CHAPEL HILL PLANNING BOARD
SEPTEMBER 18, 2007
PUREFOY DR S.U.P.
HANDOUT FROM NEOLA JONES
7 PAGES INCLUDING MAP,

STORMWATER FACTS & FINDINGS FOR PROPOSED PUREFOY ^{DRIVE} ROAD SUBDIVISION

ALTERNATE KREFOY ROAD SUBDIVISION STORMWATER PROPOSAL FROM ZUGERS ROAD SAP TASK FORCE

2 OF 10

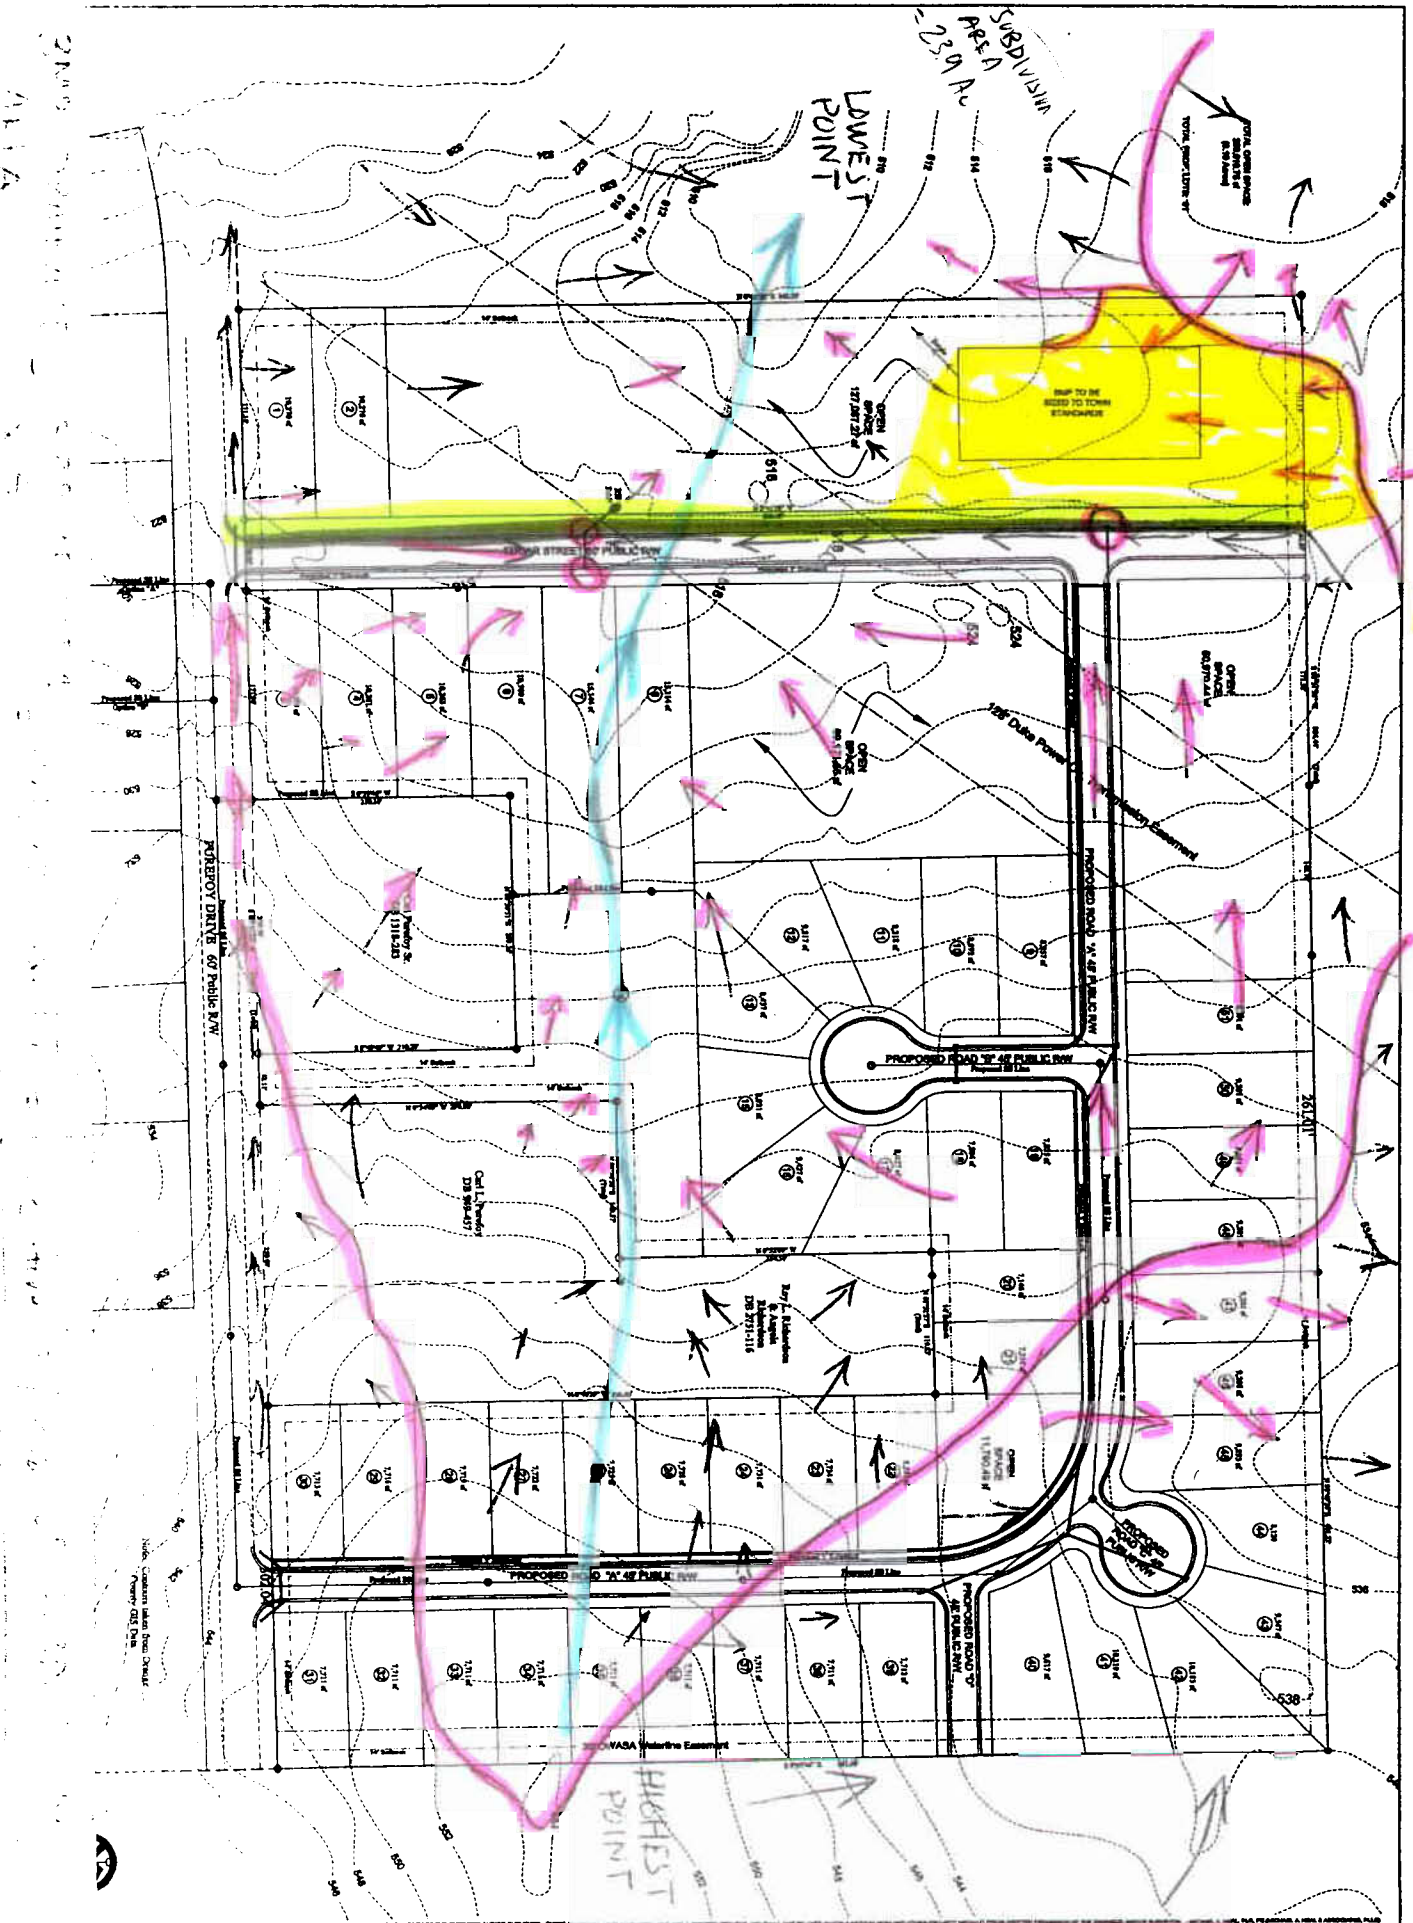
- 1) BMP SHOULD BE SIZED TO THE DRAINAGE AREA IT SERVES, NOT STRICTLY TO A REGULATORY REQUIREMENT. A SMALL AREA DRAINS TO BMP (HIGHLIGHTED IN YELLOW ON PG 2 OF 10), SO THE BMP SHOWN ON SITE PLAN LOOKS OVERSIZED.

- 2) BMP IS IMPROPERLY LOCATED BECAUSE IT IS NOT LOCATED IN A NATURAL DRAINAGE COURSE (BLUE LINE ON PG 2 OF 10) AND NOT MEETING "BEST USES" OF BMP'S (PAGES 6 AND 7 OF 10)

- 3) THE BMP DOES NOT SERVE THE SUBDIVISION FOR SEVERAL REASONS.
ONE MUCH OF THE SUBDIVISION DRAINS AWAY FROM THE BMP (AREA NORTH, EAST, AND SOUTH OF RED LINE SHOWN ON PG 2 OF 10.)
TWO, BECAUSE EXISTING EDGAR STREET ALREADY FUNCTIONS LIKE A DAM—AND WILL BECOME EVEN MORE SO WHEN CURB AND GUTTER ALONG IT CHANNELS STORMWATER TO CATCH BASINS (CIRCLED IN RED ON PG 2 OF 10)—THE BMP DOES NOT RECEIVE STORMWATER FROM THE SUBDIVISION. CURB AND GUTTER (SHOWN AS GREEN LINE ON PG 2 OF 10) PREVENTS STORMWATER FROM FLOWING TO BMP. **THREE**, TWO THIRDS OF THE STORMWATER IN THE AREA NORTH OF PUREFOY DRIVE AND WEST OF EDGAR STREET DOES NOT FLOW TO THE BMP. STORMWATER FLOWS TO THE NATURAL DRAINAGE COURSE (BLUE LINE ON PG 2 OF 10)

- 4) THE BMP TREATS VERY LITTLE STORMWATER IN THE VICINITY, ONLY ONE DRAINAGE COURSE ~~EXIST~~ NATURALLY EXISTS IN THE VICINITY (BLUE LINE ON

Alternate Stormwater Design

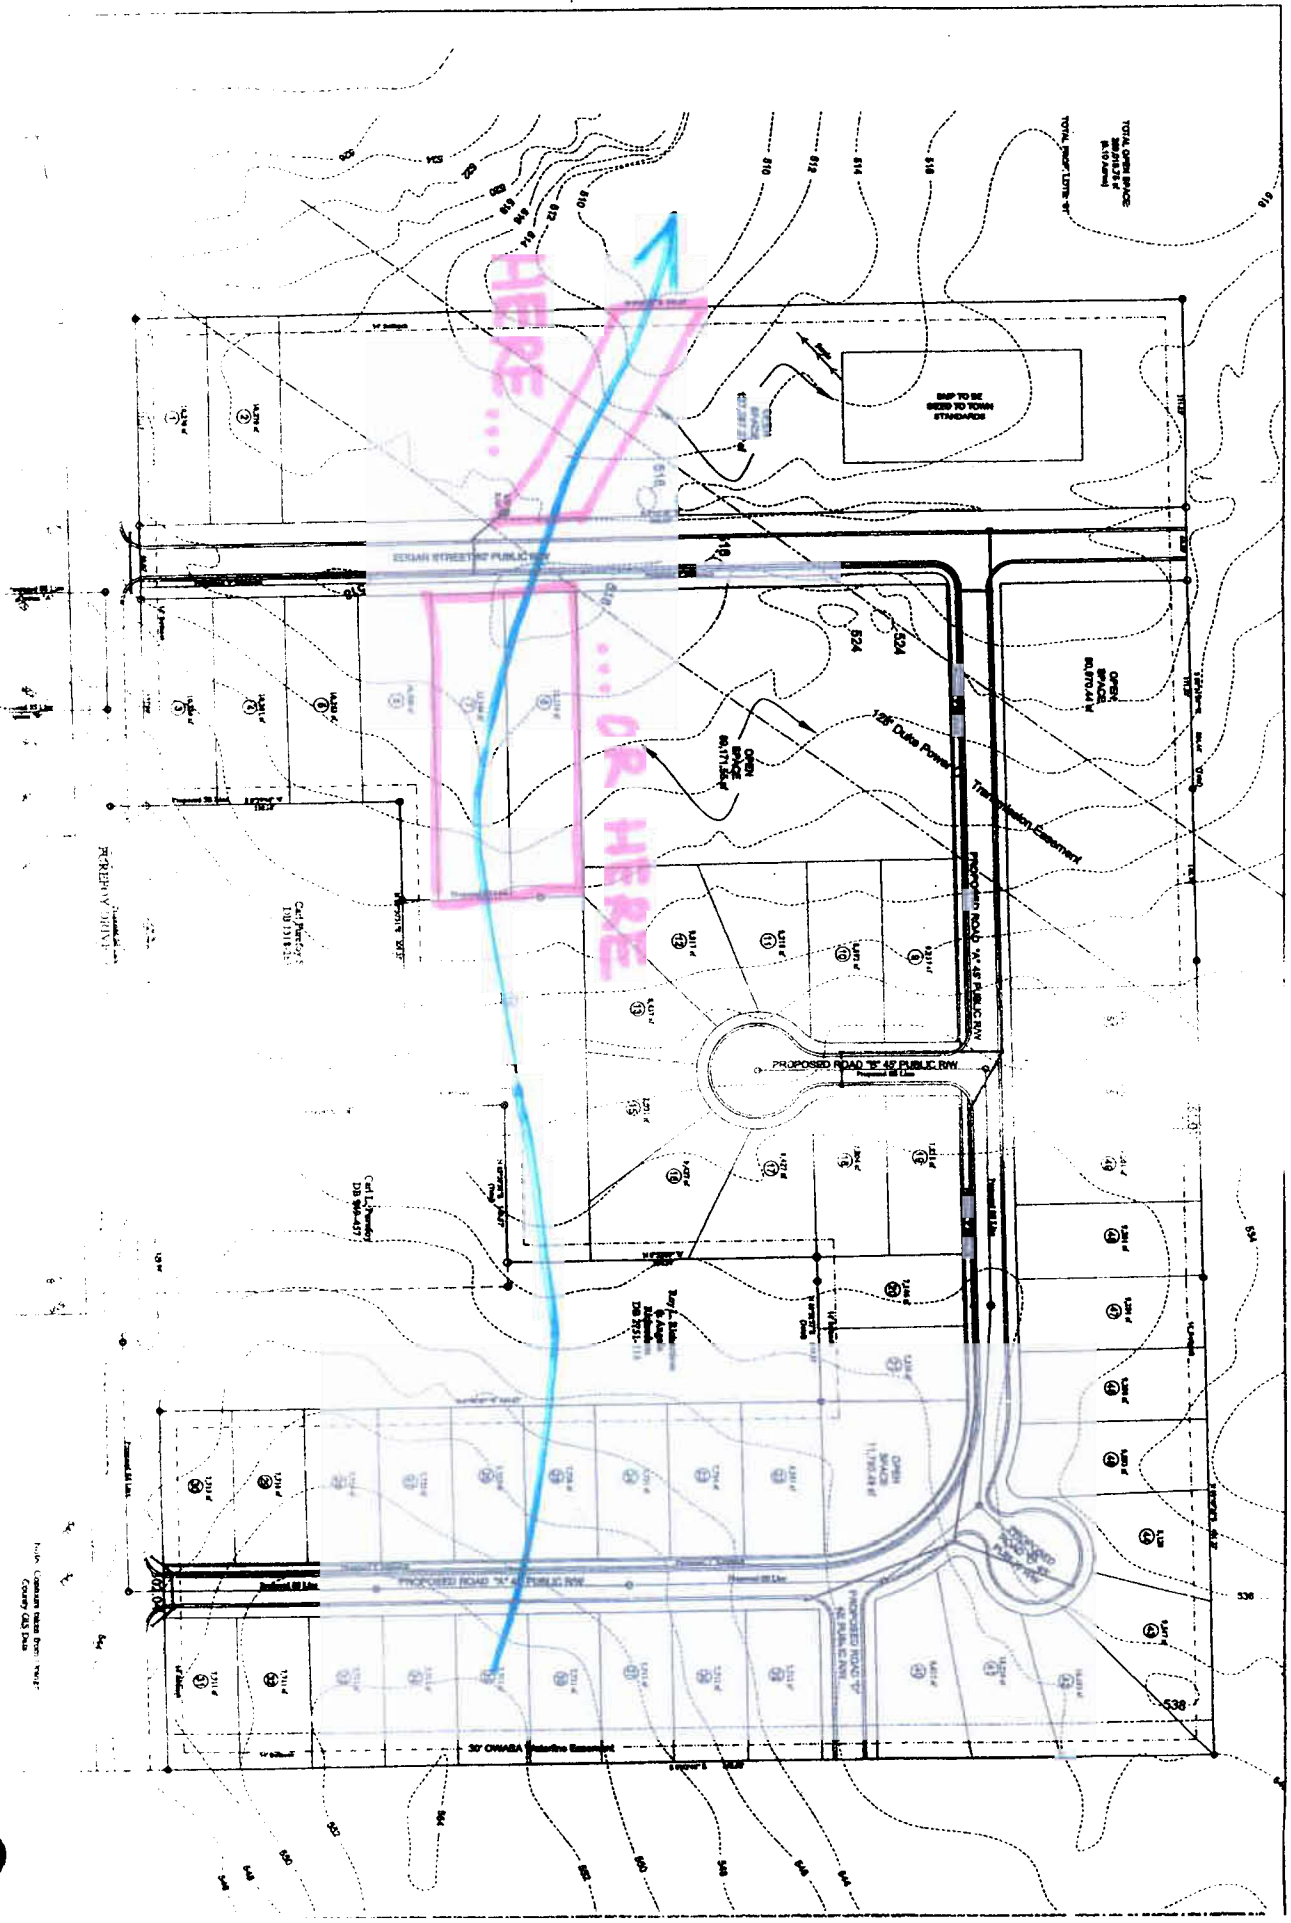
EDGAR STREET IS "PIVOTAL" POINT OF ANY STORMWATER PLAN BECAUSE: ONE, IT IS THE LOWERMOST POINT IN THE SUBDIVISION WHERE EVERYTHING DRAINS; AND TWO, IT ACTS AS A DAM—WITH OR WITHOUT STORMWATER DEVICES—CAUSING WATER TO COLLECT BEHIND IT. FOR THESE REASONS, WATER QUANTITY, NOT WATER QUALITY, ARE THE ISSUES MOST ASSOCIATED WITH EDGAR STREET.

SUBDIVISION MAY COME TO A "WATER QUALITY" ISSUE AFTER CONSTRUCTION. PAIRED WITH THE INCREASE OF FLOW FROM IMPERVIOUS SURFACES, SEDIMENTATION WILL AGGRAVATE THE FLOODING PROBLEM OCCURRING ON LOTS 7 & 8 WHERE NO STORMWATER COLLECTION DEVICES ARE PROPOSED.

- (1) DECREASE STORMWATER QUANTITY TO IT BY ROUTING THE SUBDIVISION'S NORTHEAST STORMWATER (HIGHLIGHTED IN RED) BACK TO WHERE IT ORIGINALLY DRAINED (LOT 45.)

- (a) DECREASE THE DRAINAGE AREA AT EDGAR STREET FROM 19 AC TO 16 AC.
 - (b) REDUCE PIPE NEEDED RE-ROUTE STORMWATER (SEE X'S FROM STATION 21+70 TO 25+30) AND SAVE PROJECT COSTS.
- (2) INSTALL CROSS PIPE BENEATH EDGAR STREET AT APPROXIMATE STATION 13+60
 - (3) INSTALL DROP INLET ON LOT 8 TO COLLECT STORMWATER DRAINING FROM SUBDIVISION AND TRANSMITTING IT TO CROSSPIPE BENEATH EDGAR STREET. THE DROP INLET WILL RETAIL:
 - (a) NEW DETAIL FOR DROP INLET
 - (b) NEW DETAIL FOR DROP INLET GRATE & COVER
 - (4) MOVE PROPOSED CATCH BASINS FROM STATION 13+05 TO STATION 13+60

THESE RECOMMENDATIONS ARE INTENDED TO PREVENT FLOODING ON LOTS 7 & 8, DECREASE PIPE NEEDED FOR DRAINAGE, DECREASE SIZES OF STORMWATER DEVICES NEEDED, AND MINIMIZE FLOW DIRECTED TO EDGAR STREET
